**ATTACHMENTS / PARTS**

**Model Affected:** 42" 3X Snow Thrower (19A40024100)

**Date:** September 15, 2015

**Subject:** Incorrect Length Snow Thrower Lift Cable Assembly

**FIGURE 1**

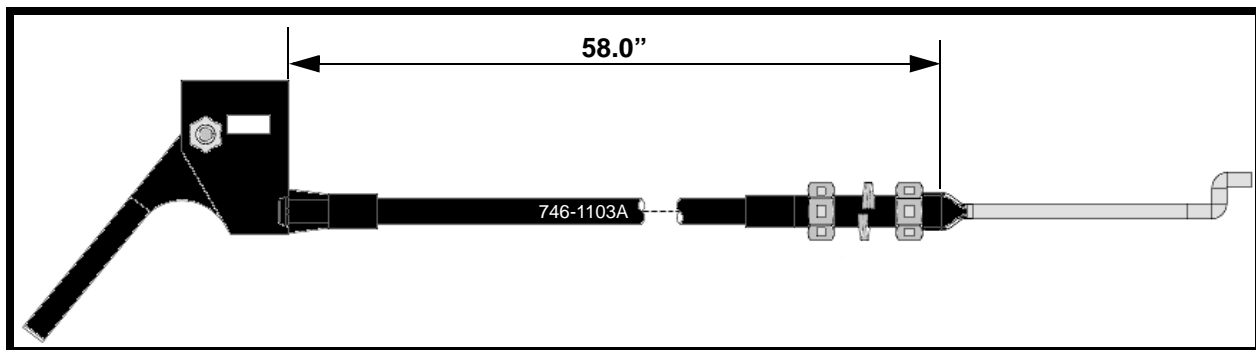
It has come to our attention that the above listed Model in the Serial Number Range Affected, had the incorrect snow thrower lift cable with trigger packaged with the **42" 3X Snow Thrower**. The incorrect snow thrower lift cable **746-1103A** measures 58.0" as shown in Figure 1.

1. Check if your inventory includes the above listed Model in the affected Serial Number Range.
2. Order from your parts source, Qty. (1) **946-05201** Snow Thrower Lift Cable. **NOTE: The 946-05201 cable measures 65.50" from the same reference points as shown in Figure 1.**
3. Remove the **746-1103A** lift cable from the **42" 3X Snow Thrower** packaging and place in your parts inventory. **NOTE: The 746-1103A is used on the following Models of Snow Throwers; 032** (190-032-101, OEM-190-032). **341** (190-341-100). **673** (190-673-100). **823** (190-823-101). **19A126** (19A-126-100).
4. Install the **946-05201** Snow Thrower Lift Cable when assembling the **42" 3X Snow Thrower**.
5. Submit a warranty claim for parts and labor (one Snow Thrower per claim).
